**COMMITTEE OF EXPERTS ON THE TRANSPORT OF  
DANGEROUS GOODS AND ON THE GLOBALLY  
HARMONIZED SYSTEM OF CLASSIFICATION  
AND LABELLING OF CHEMICALS**

**NEW PROPOSALS OF AMENDMENT TO THE RECOMMENDATIONS  
ON THE TRANSPORT OF DANGEROUS GOODS**

Impact Testing of UN Portable Tanks and MEGCs  
Proposal to change clauses 6.7.2.19.1, 6.7.3.15.1, 6.7.4.14.1, and 6.7.5.12.1 and  
the Manual of Tests and Criteria

Transmitted by the expert from Canada

**Figure 1: Minimum SRS Curve**

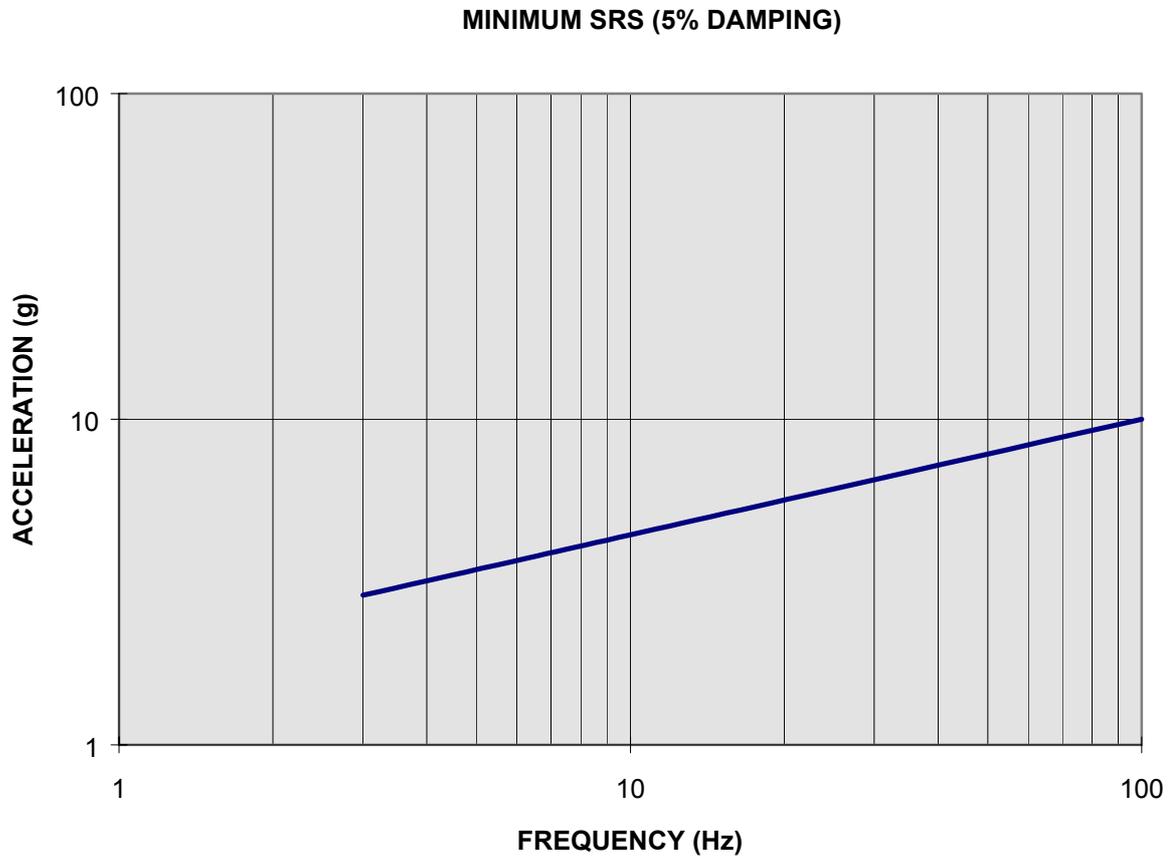
3.4.4 An impact shall be created (see section 3.2) such that for a single impact the as tested Shock Response Spectrum (SRS, see section 3.5.1) curve at both corner fittings at the impacting end equals or exceeds the minimum SRS curve shown in Figure 1 at all frequencies within the range from 3 Hertz to 100 Hertz. Repeated impacts may be required to achieve this result but the test results for each impact shall be considered individually;

Equation for generating the above Minimum SRS Curve:  $ACCEL = 1.95 \text{ FREQ}^{0.355}$
